Subject: Control Room Design Review/Audit Report, Palo Verde Nuclear  
Generating Station

HUMAN FACTORS ENGINEERING  
CONTROL ROOM DESIGN REVIEW/AUDIT REPORT

PALO VERDE NUCLEAR GENERATING STATION  
ARIZONA PUBLIC SERVICE COMPANY

FIG. 1. Identification of control board surfaces.

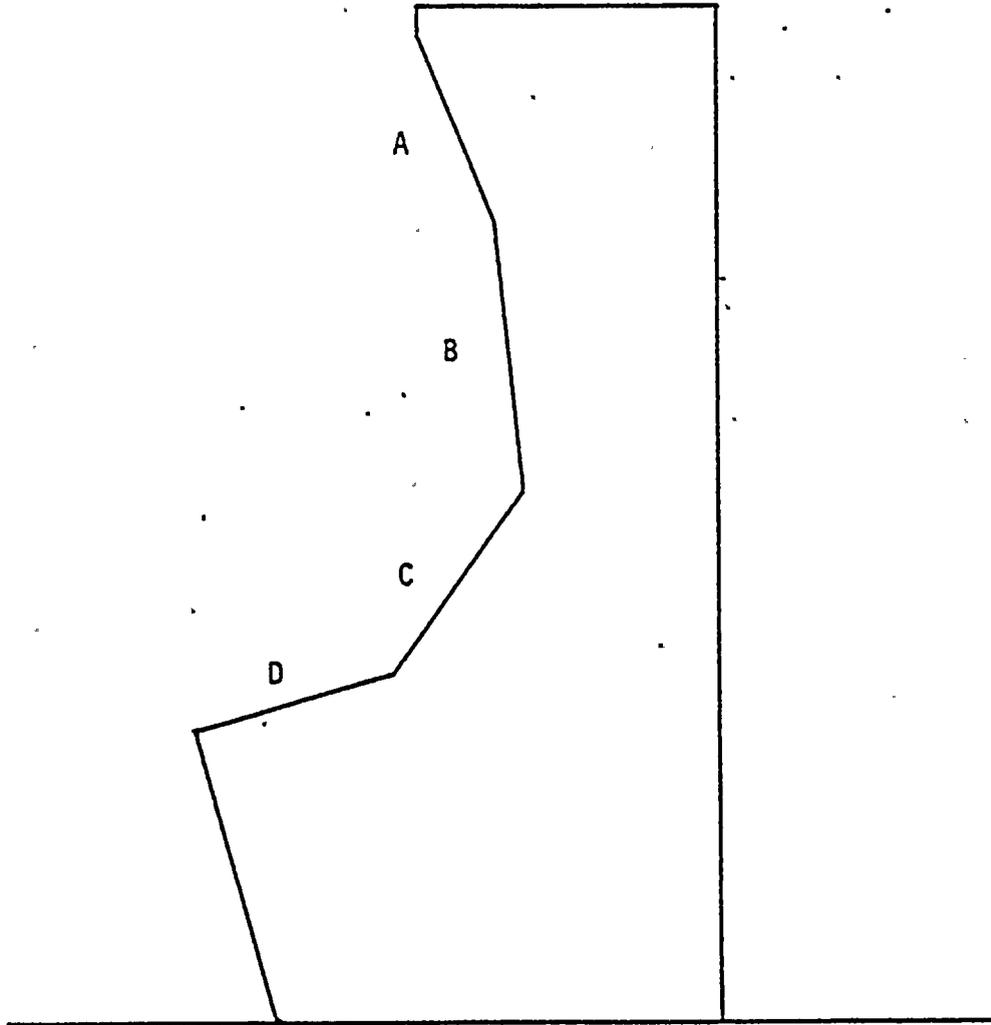
<u>PRIORITY RATING</u>	<u>FINDING</u>
3	1* The control room bookshelves are inadequate. (056C)
2	2* Glare is a problem for most displays on all of the panels. It is worst on the "C" surfaces, depending on viewing angle. (See Fig. 1 on page 3 for the meaning of "A", "B", "C, and "D" surfaces.) (049C) (064C) (100B) (101B) (103C)
1	3* Glare on CMC switch surfaces hinders "light-on" determination. This is more apparent on the "C" surfaces. A matte surface might not be as effective a solution as brighter lights. Example: (Panel B02) a.) ESF SWGRA/EQPT Room switch (098C)
3 <sup>1</sup>	4* The concrete control room floor is not carpeted, which will lead to earlier fatigue during long periods of standing by the operators. (068B)
